RE: West Bay Yards Mixed Use Development – Partial Response to November 2023 Review
Project No. 21-2854

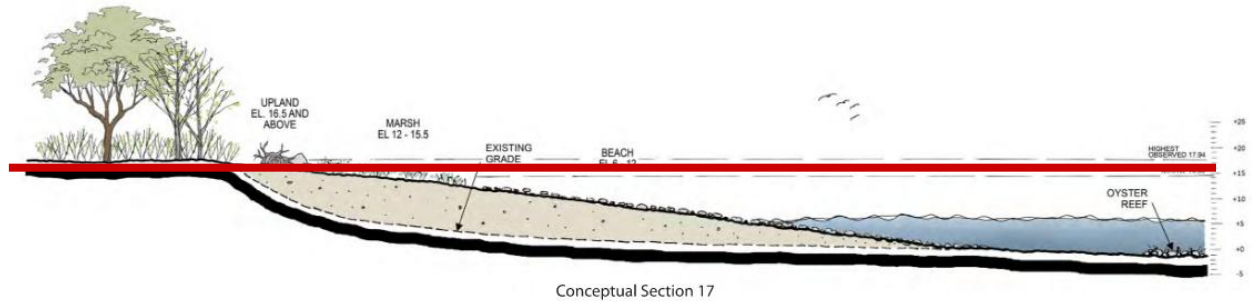
In previous communications with the City, the Applicant has argued that this additional upland is consistent with the Assessment Report. However, as the City reads the Assessment Report, particularly the call for essentially maintaining the existing uplands and shoreline plan form, it does not contemplate conversion of intertidal area to new upland area as the Applicant proposes. In arguing it does, the Applicant relies on the schematic identified as “Conceptual Section 17.” That schematic shows fill waterward of the existing grade to illustrate how fill could be used to create a more naturally sloped and functional beach. The City believes that the applicant is mis-reading this schematic and placing undue reliance on it based on this mis-reading. Importantly, this schematic lacks critical information, which requires the reader to make certain assumptions. For example, the document identifies “upland” at 16.5 feet elevation, but does not identify where the Ordinary High Water Mark is located. The image shows a Mean Higher High Water Line (MHHW) at 14.5 feet (bottom dashed line), which is similar to the OHWM, but these two measurements are not identical. The Ordinary High Water Mark is shown on the applicant’s proposed plan set but must be converted from NAVD88 to MLLW Datum to correlate to this document. By doing this, one can see that the Ordinary High Water Mark is at about 15.5 feet on this image (11.5 in NAVD88). A red line has been added below to show the approximate location of this point:

The red line in the image above could not have been determined without additional information, from other sources. With the additional information, it is easier to see that a waterward shift of the upland area is not called for by this schematic.

In any event, The City believes this schematic was not intended to be used as the Applicant is using it. This schematic, like others in the Assessment Report, was intended to be conceptual in nature, and to show that the existing uplands/shoreline plan form could be maintained more-or-less as they are, and that fill could be placed at or below the existing Ordinary High Water Mark to achieve the intended restorative effect. It is important to note that the Assessment Report repeatedly reiterates that the projects recommended are conceptual in nature and that any restoration project would be expected to be reviewed for compliance against the City's SMP regulations at the point that a detailed project plan was prepared.
